# ADA Curb Ramp New Construction Inspection Form (Perpendicular)

Nw 285 ave

24952.54

Nw Shaddon st

## PERPENDICULAR RAMP (PR)

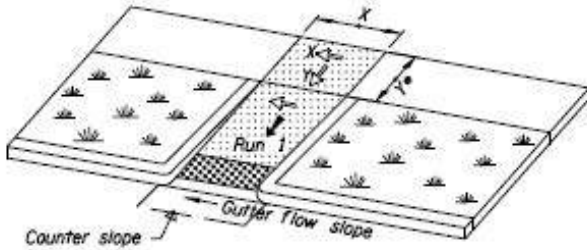
RR 1 ICRR clear width less than 4'
